**SMYRNA SCHOOL DISTRICT**  
**Smyrna Elementary School Renovations and Addition**  
**Bid Number SSD-15-001**

ADDENDUM NO. 4

2 April 2015

ARCHITECT'S PROJECT NO: 14107a

DRAWING TITLE:  
POST-CONSTRUCTION SITE  
STORMWATER MANAGEMENT PLAN

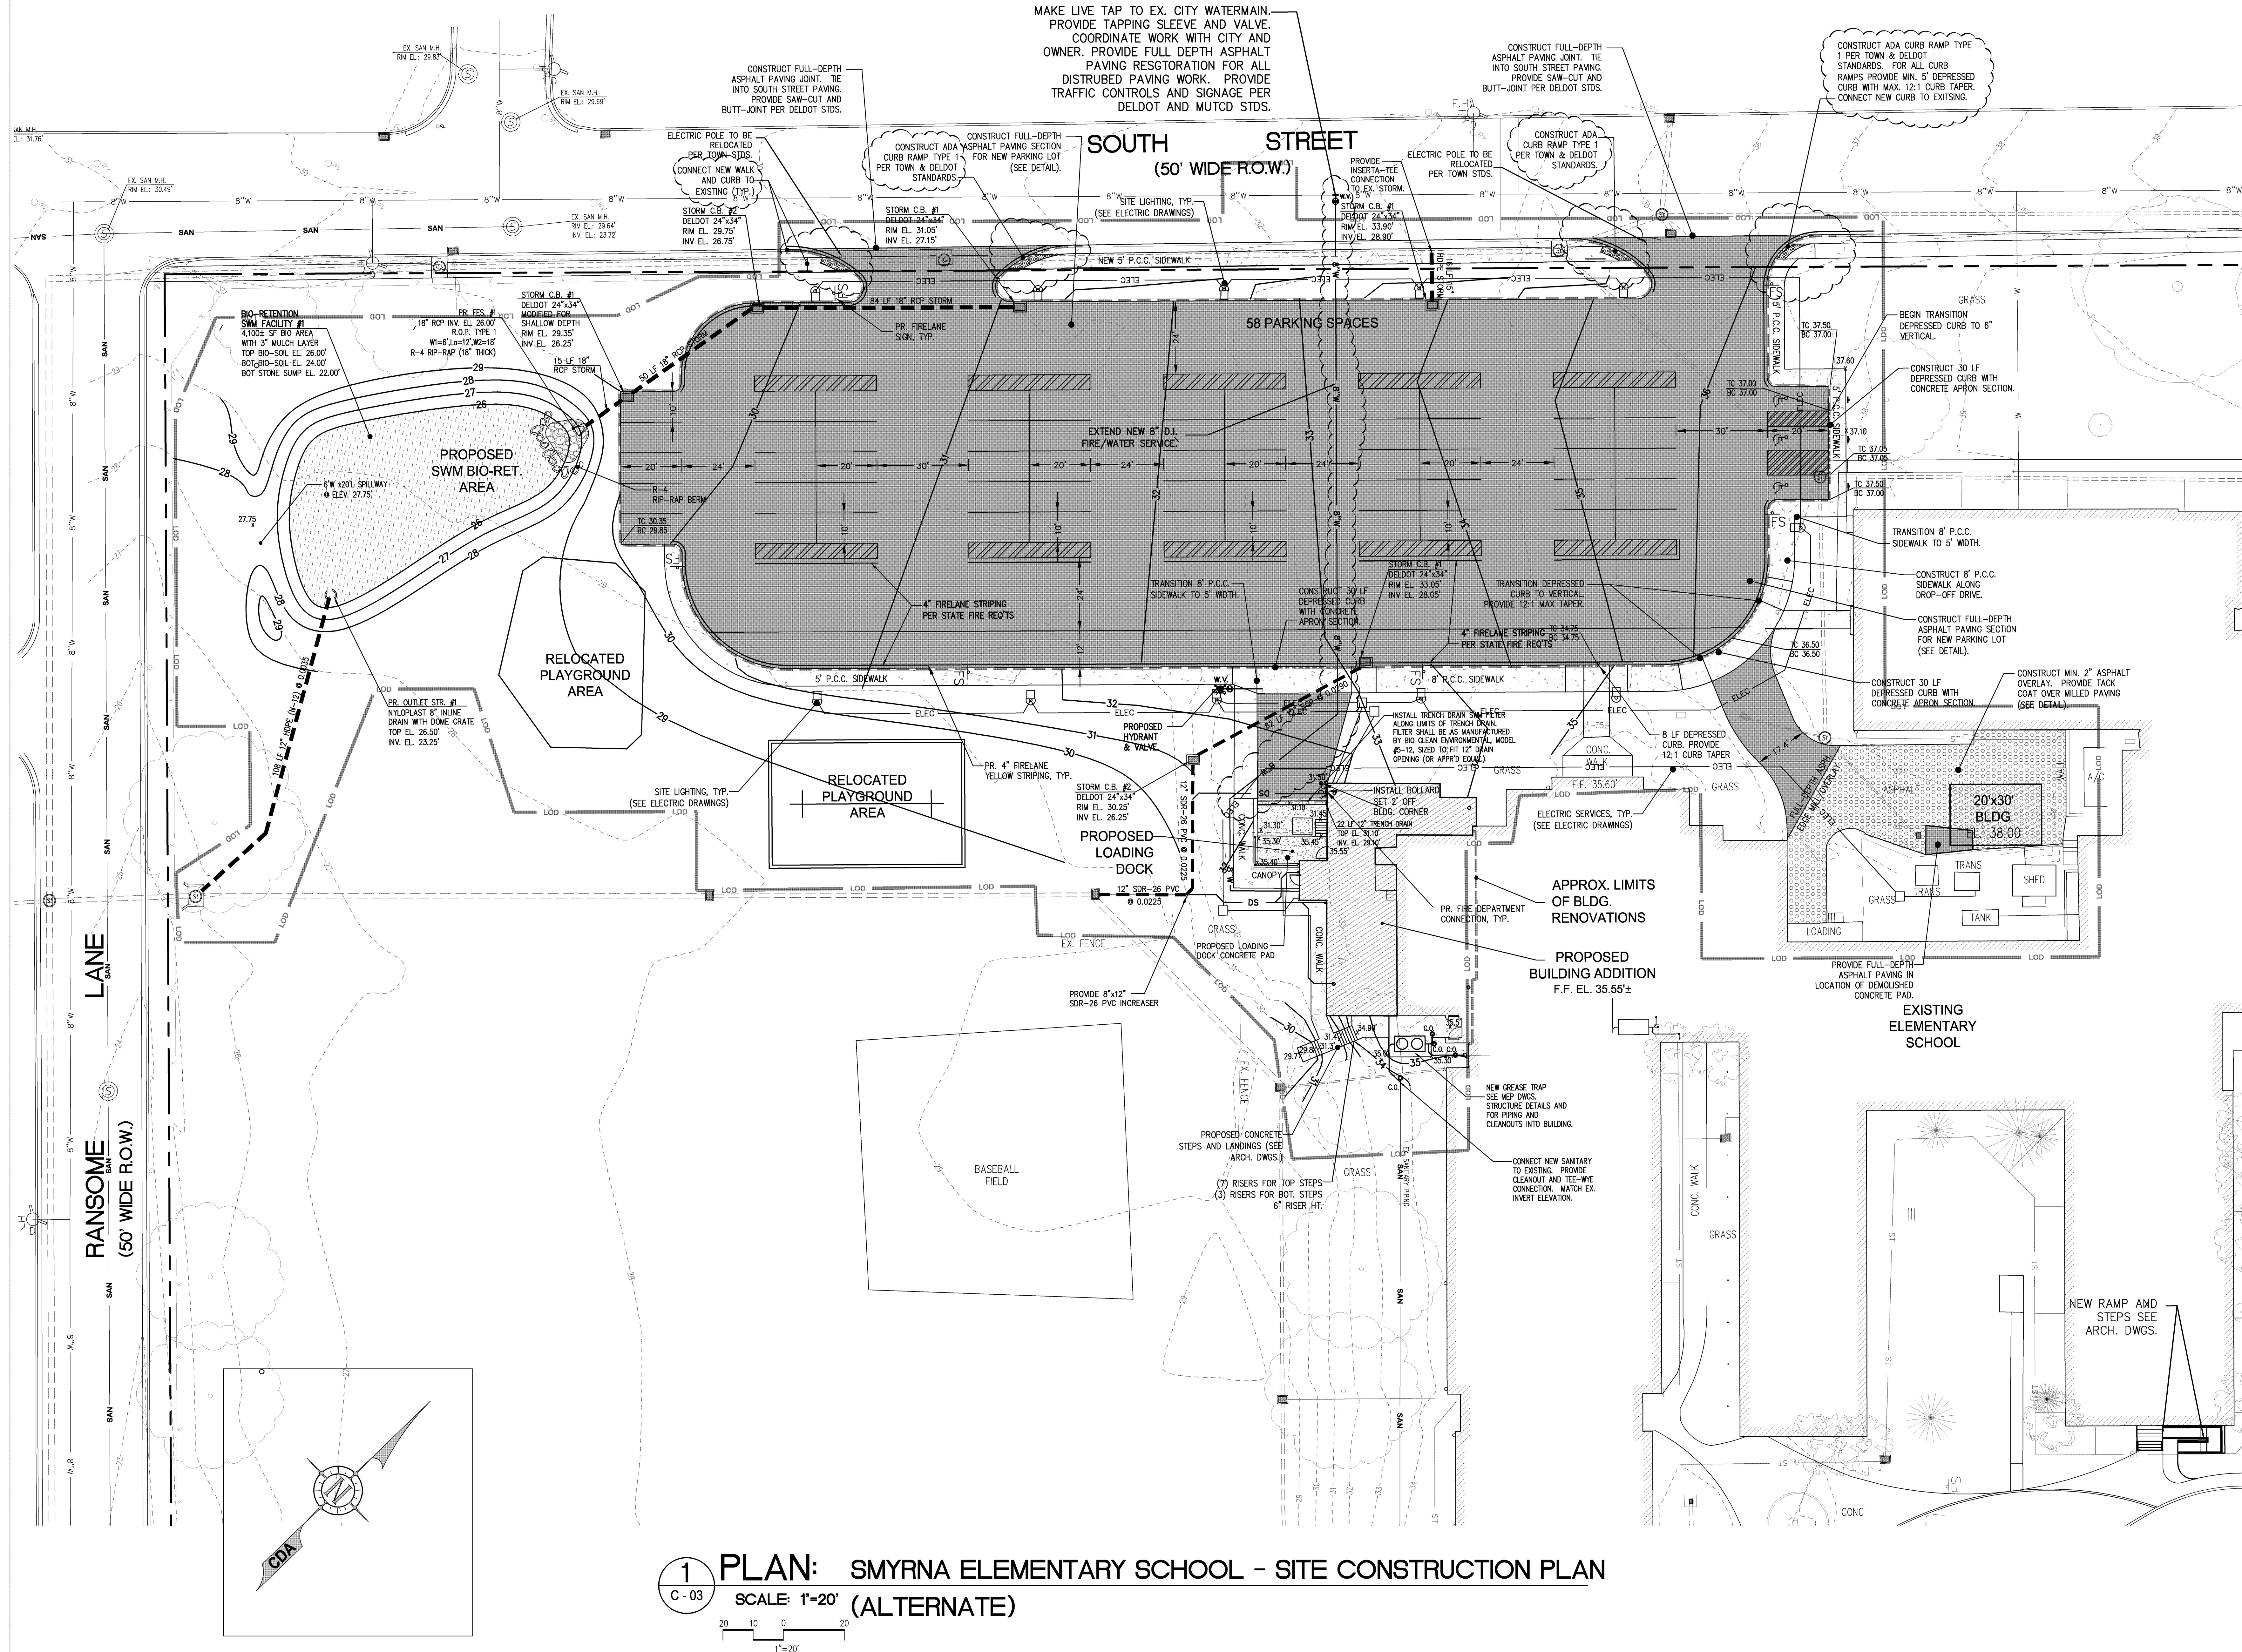
2.4 **Q:** Drawings C-03 and C-04 show relocated playground areas. Are we to remove and reinstall? Where will it be taken? Is this by the owner? If by the GC, please provide a scope of work.

2.8 **Q:** The tree where the new 8" water line is shown is called out to be saved. Can this tree be removed or should the water line be routed around the tree?

**A:** Water line has been adjusted to avoid conflict with existing tree. See attached C-04 and C-04 (ALT) drawings.

DATE: 04-02-15 DRAWING NUMBER: A80-01

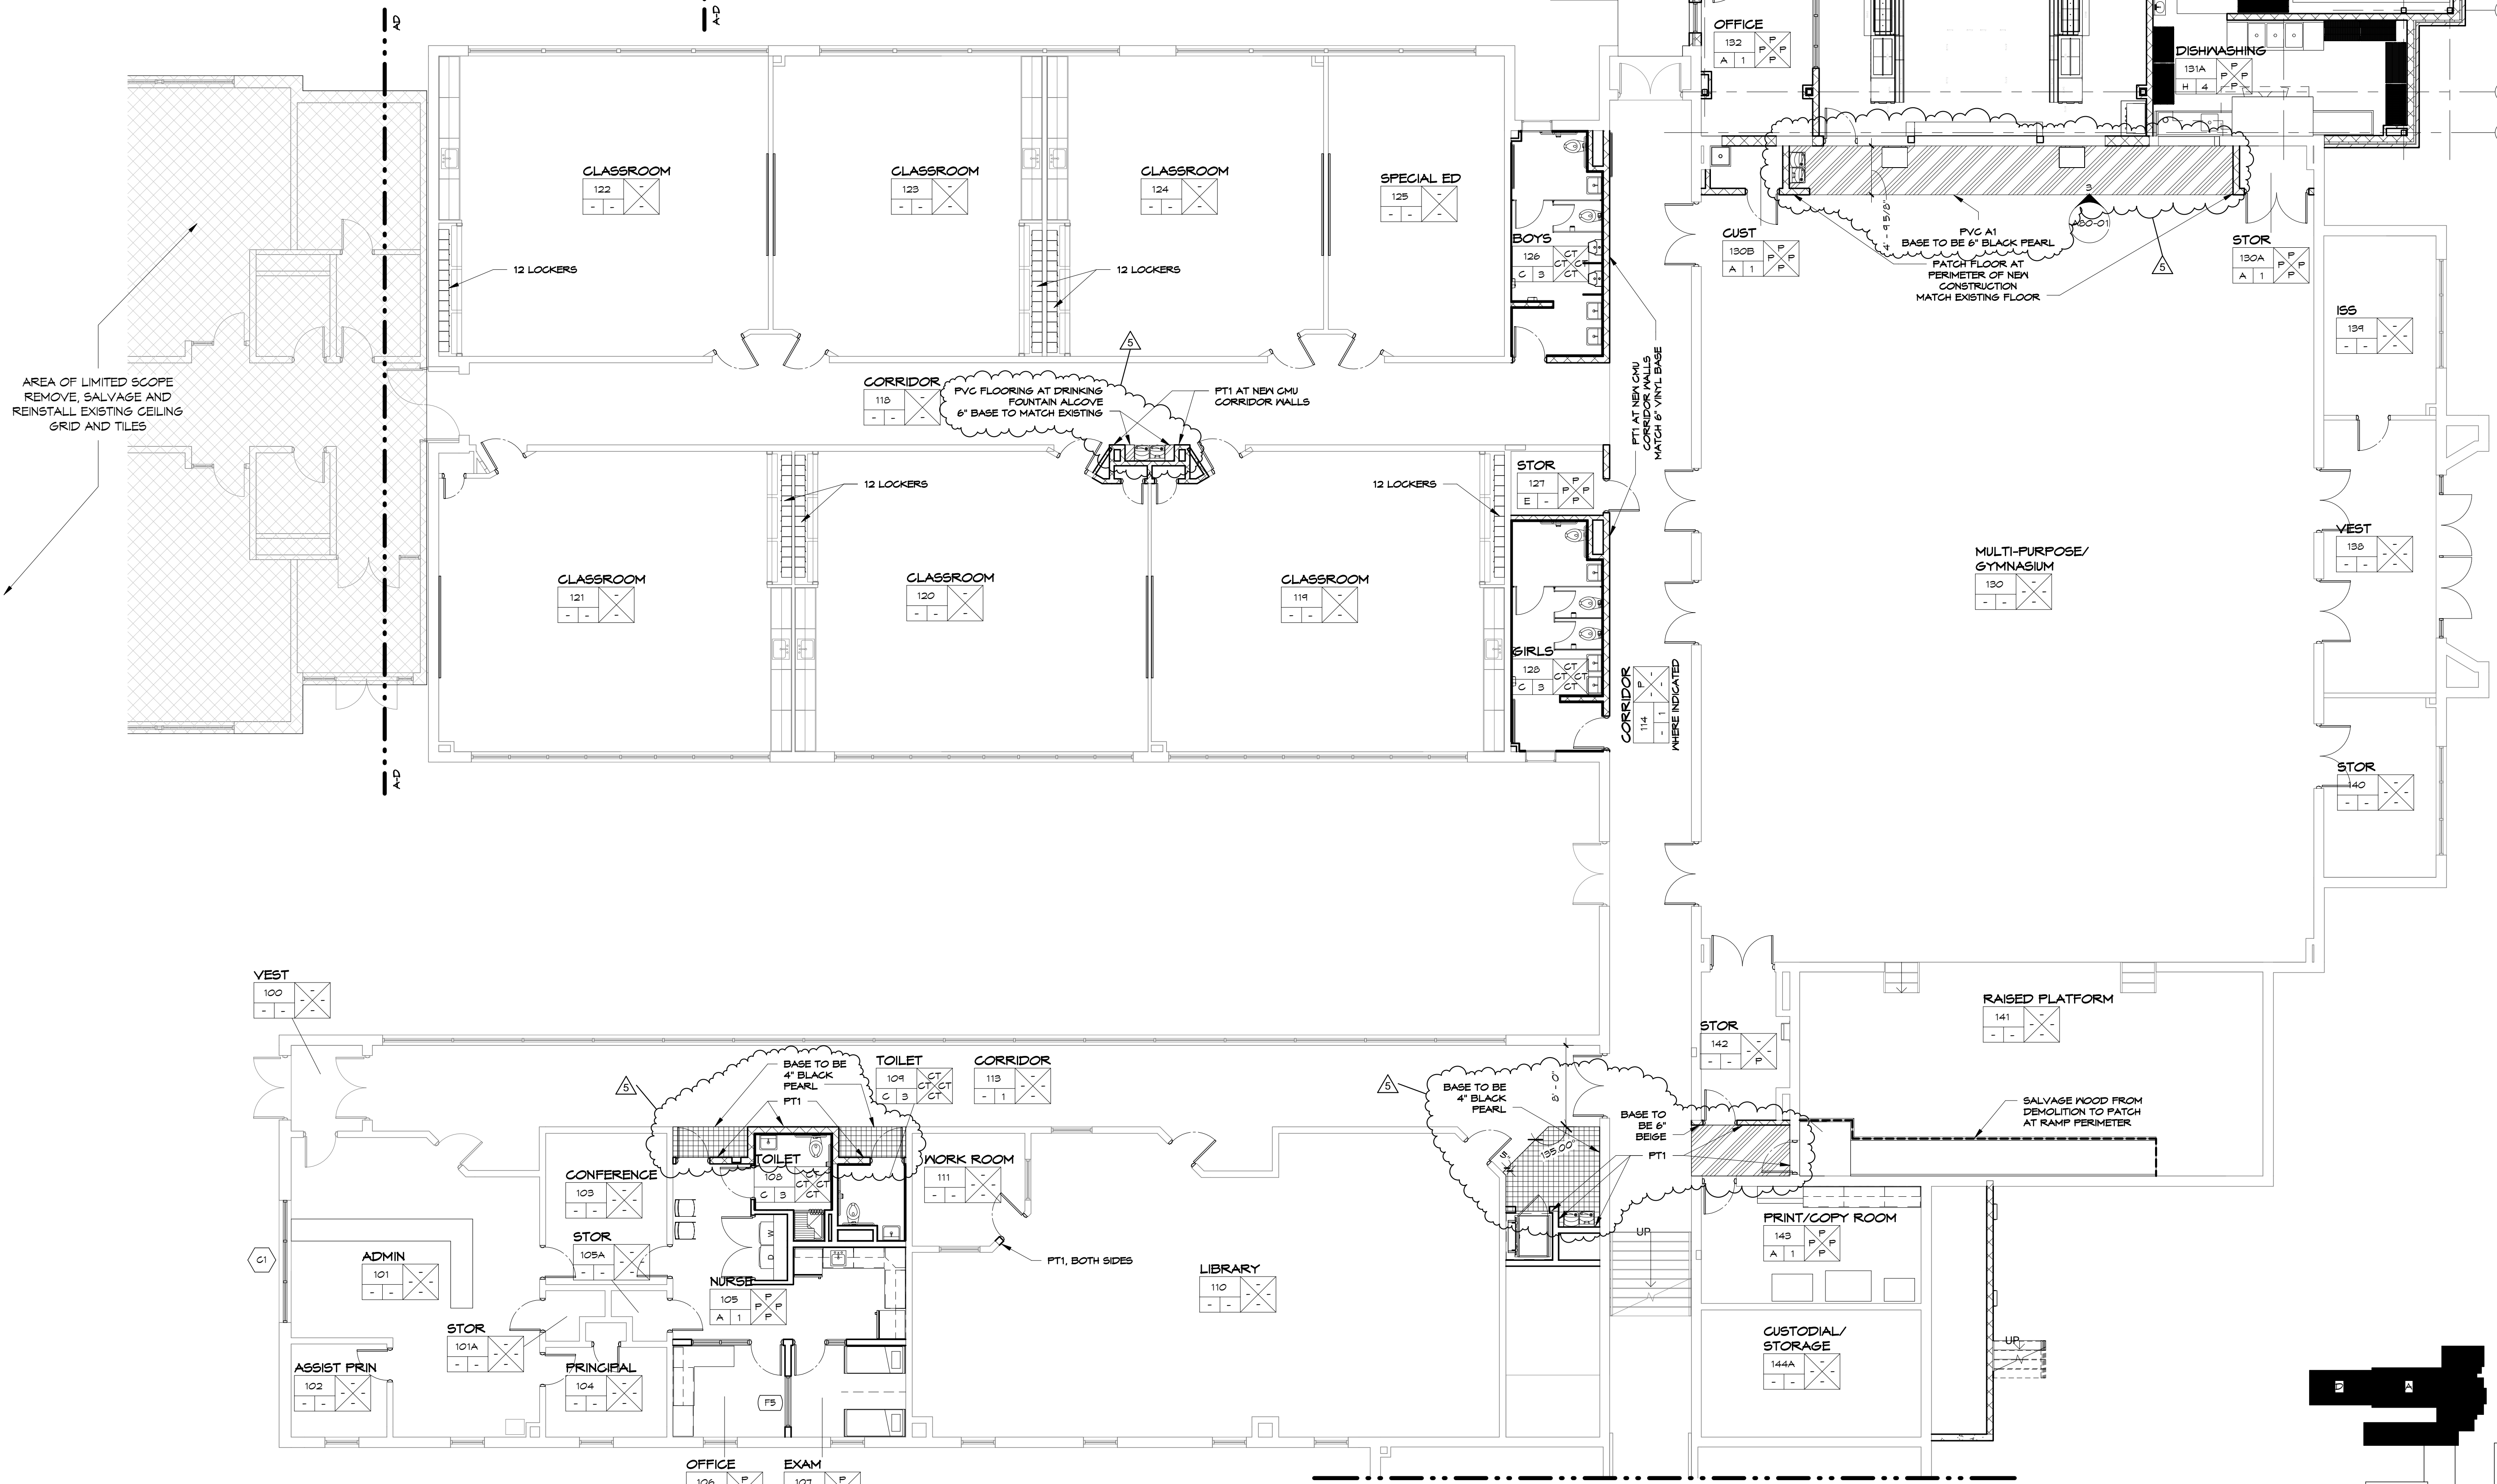
2.16 **Q:** Resilient Tile Flooring spec page 2, item 2.1.A states “solid PVC floor tile according to the Finish Drawings and Schedule”, however Finish Plans A80-01 & A80-02 do not list the product to be used. Please advise.

**A:** Existing PVC floor tile is Manufacturer: Toli ; Style Linotesta; Size 17.7”, Gauge .120”. See Finish Specifications and Legend located on revised Sheet A80-02.
